# **CHARLES RIVER DAM**

## **DESIGN MEMORANDUM NO. 2**

**GENERAL DESIGN, SITE GEOLOGY AND  
RELOCATIONS**

DAEN-CWE-B (NEDED-E, 14 February 1972) 1st Ind  
SUBJECT: Charles River Dam, Boston, Massachusetts, Design Memorandum  
No. 2, General Design, Site Geology and Relocations

WATER RESOURCES DEVELOPMENT PROJECT  
CHARLES RIVER LOCKS AND DAM  
GENERAL STRUCTURE PLAN

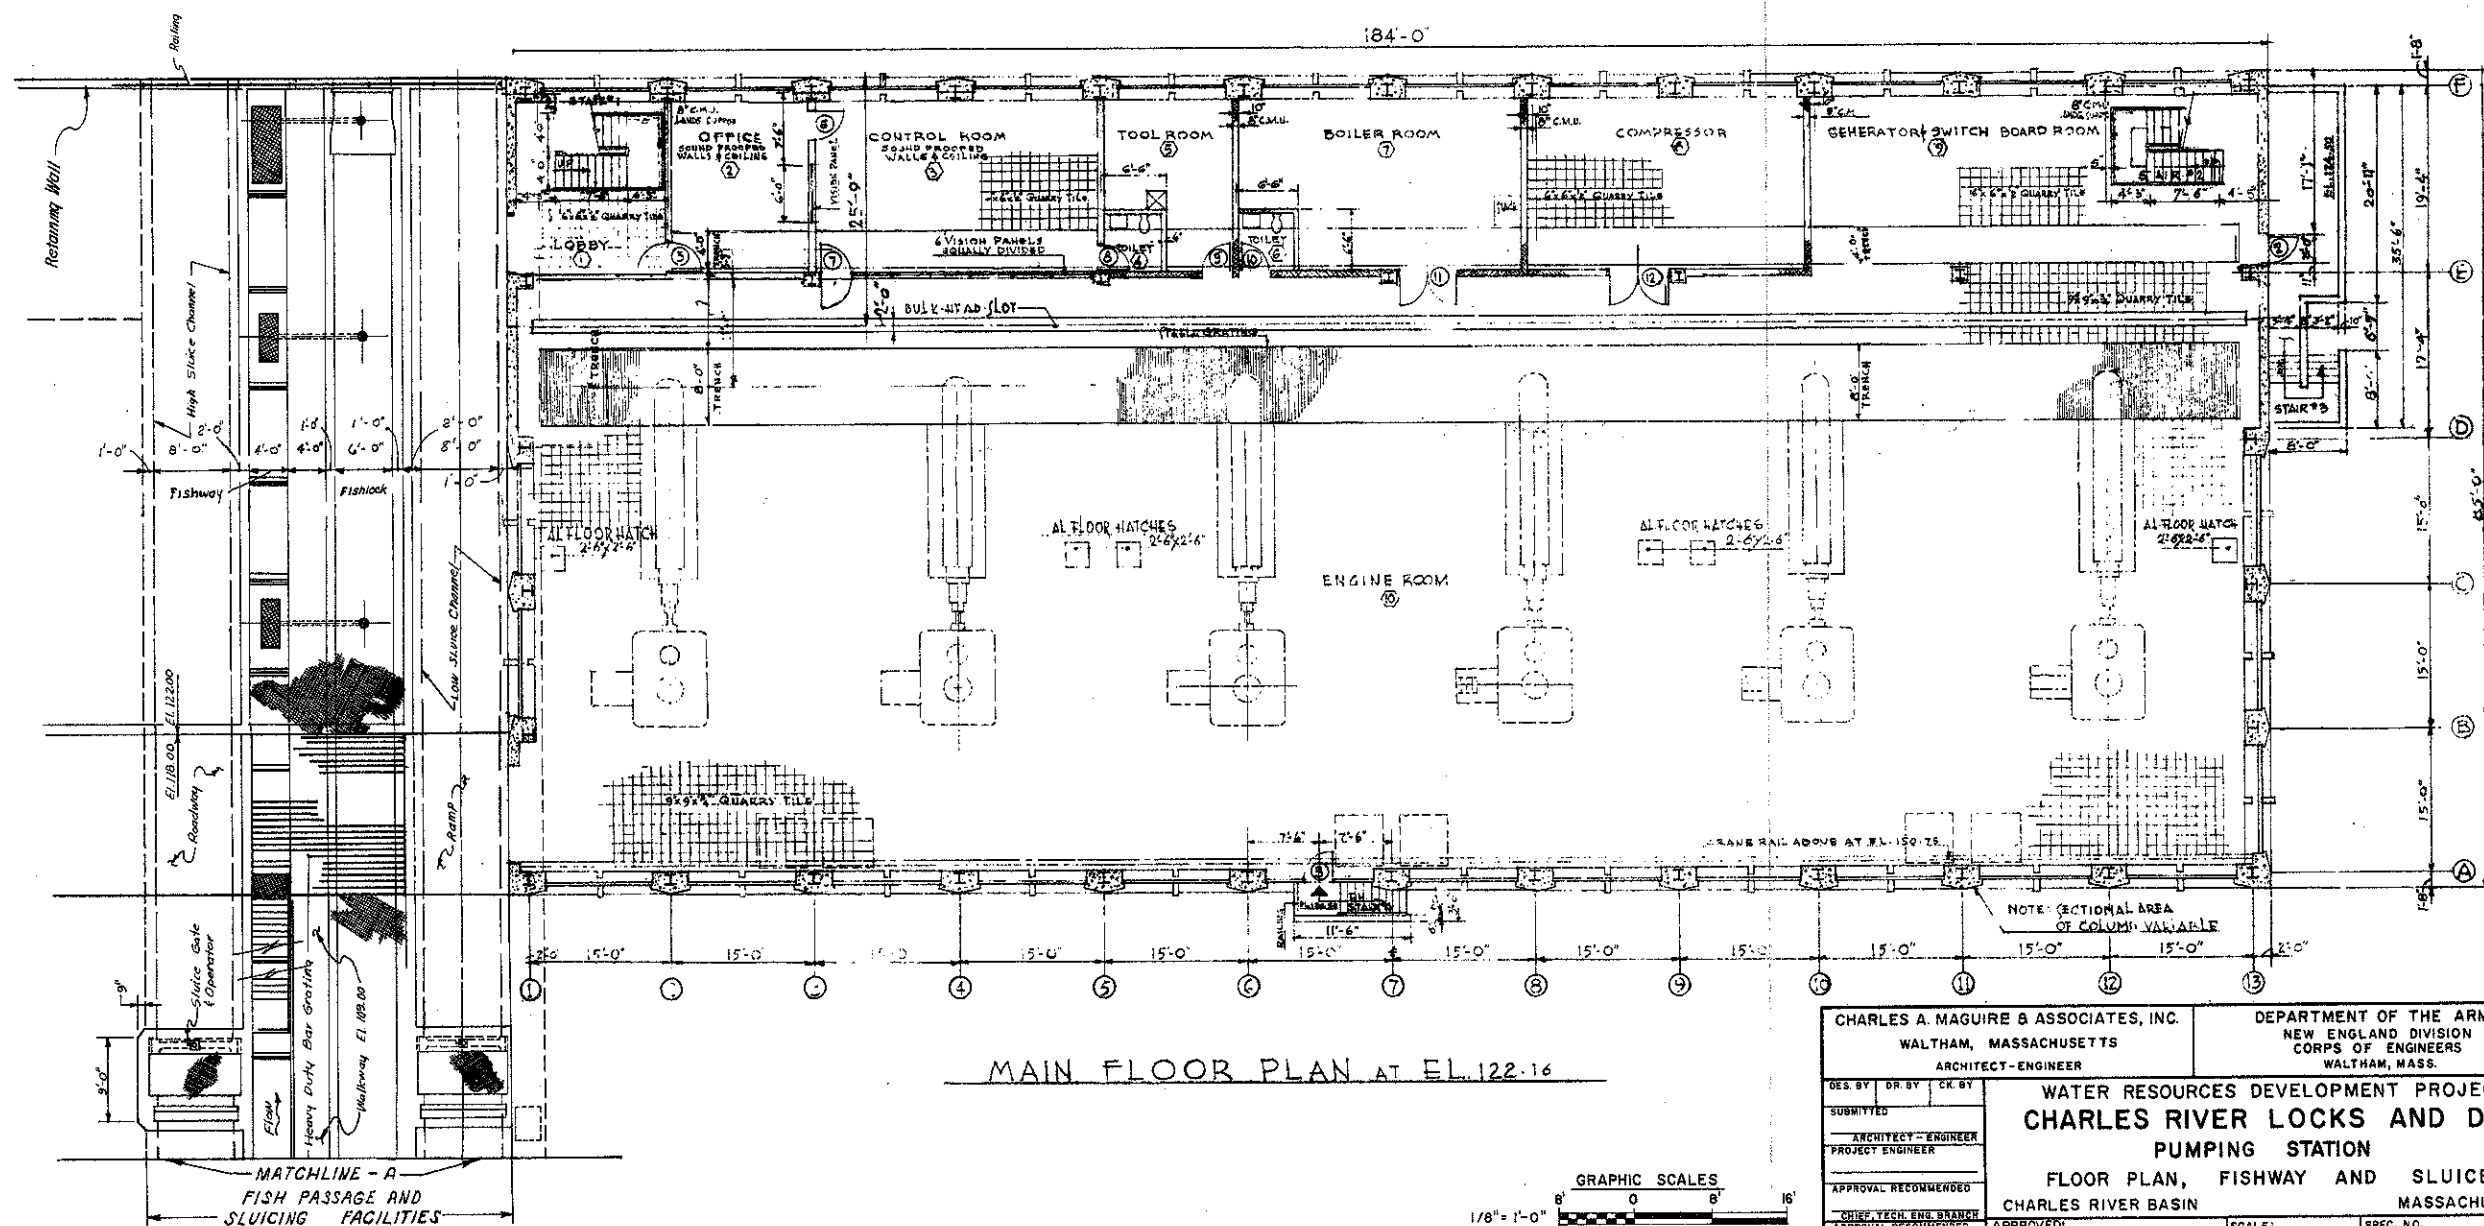
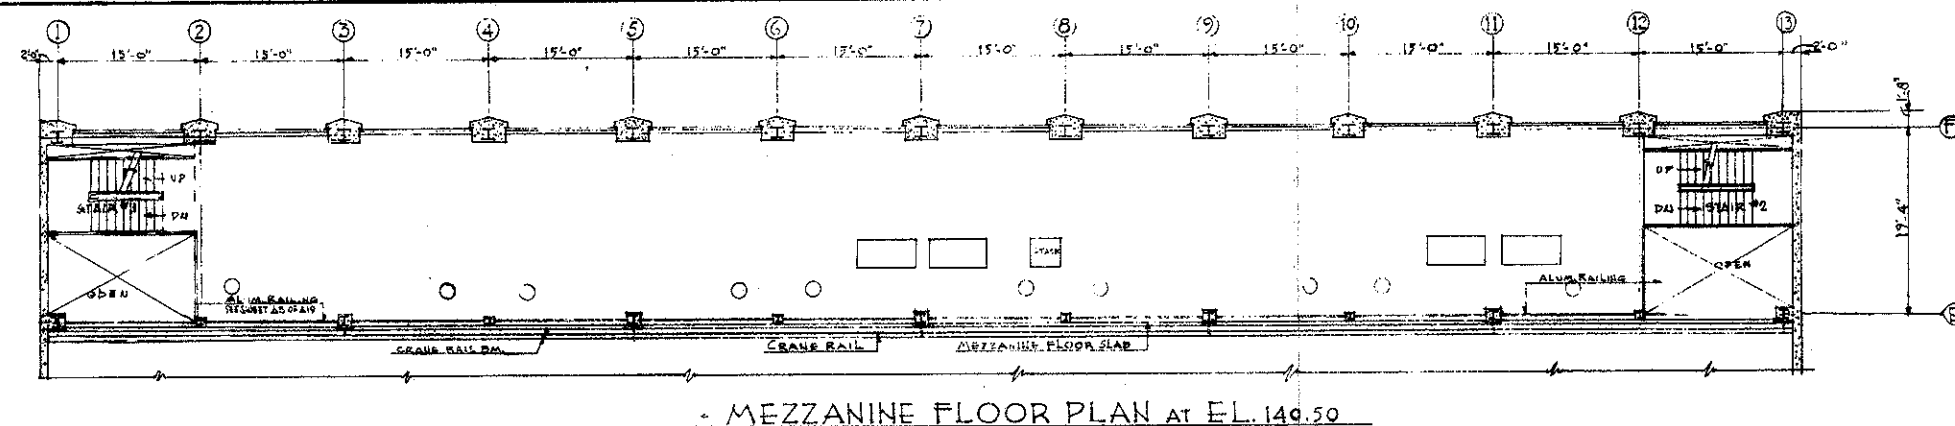
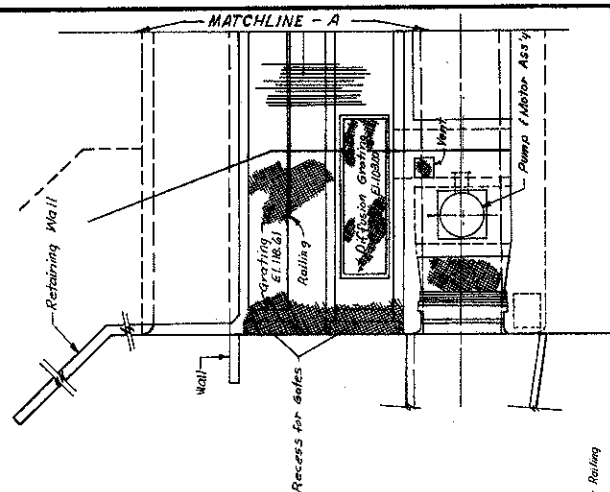
13. Plates 2-5 and 2-6. It appears that filling and emptying culverts around the sector gates with sluice gates for valves are to be provided. The need for, and arrangement of these culverts appear questionable, as filling and emptying will be accomplished part of the time by pumping and can be accomplished the remaining portion of the time by the sector gates.
